Access Compliance Report

Public Rights-of-Way

(Curb Ramps)

Intersection ID: 10011079	Main Street: PLAZA_WALK_DR	Cross Street: N/A	Location: SE
ADA ID: BF15AEBBCD6A	Ramp Type: Perp	Initial Pass/Fail: Fail	Overall Compliance: No
		Severity Score: 12.5

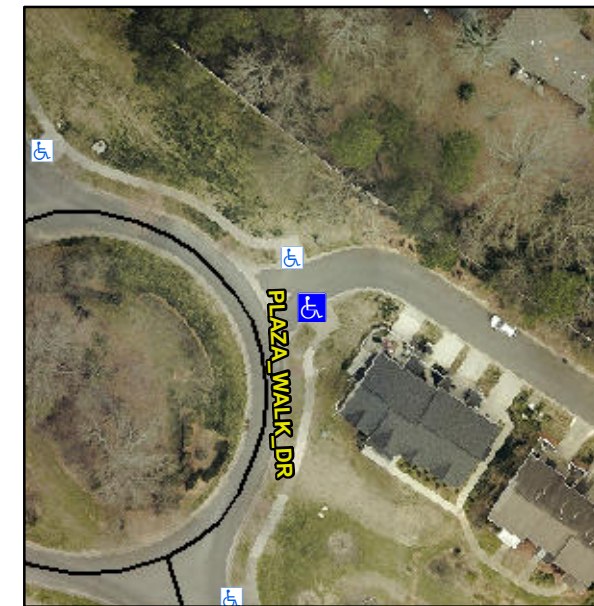
R304.2.2

Compliance	Description	Data	Compliance	Description	Data
N/A	Ramp Length (in)	98.5	No	Ramp Slope (%)	8.6
Yes	Ramp Width (in)	48.0	Yes	Ramp XSlope (%)	0.7
N/A	Flare Type LT	N/A	N/A	Flare Type RT	N/A
N/A	Flare Slope LT (%)	N/A	N/A	Flare Slope RT (%)	N/A
N/A	Flare Traversable LT?	N/A	N/A	Flare Traversable RT?	N/A
N/A	Landing Length (in)	N/A	N/A	DWS Provided?	N/A
N/A	Landing Width (in)	N/A	N/A	DWS Contrast?	N/A
N/A	Landing Slope (%)	N/A	N/A	DWS Length (in)	N/A
N/A	Landing X Slope (%)	N/A	N/A	DWS Full Width?	N/A
N/A	Landing Curb? (Y/N)	N/A	N/A	DWS Offset (in)	N/A
N/A	Shared Landing?	N/A			
N/A	Gutter Ponding?	N/A	N/A	Gutter Slope (%)	N/A
N/A	Gutter Lip Ht (in)	N/A	N/A	Gutter X Slope (%)	N/A
N/A	Painted X Walk1?	No	N/A	Painted X Walk2?	N/A
	X Walk 1 Direction	To N		X Walk 2 Direction	N/A
N/A	X Walk 1 Width (in)	N/A	N/A	X Walk 2 Width (in)	N/A
	X Walk 1 Slope (%)	1.9		X Walk 2 Slope (%)	N/A
	X Walk 1 X Slope (%)	1.4		X Walk 2 X Slope (%)	N/A

Remove & Replace Entire Ramp.
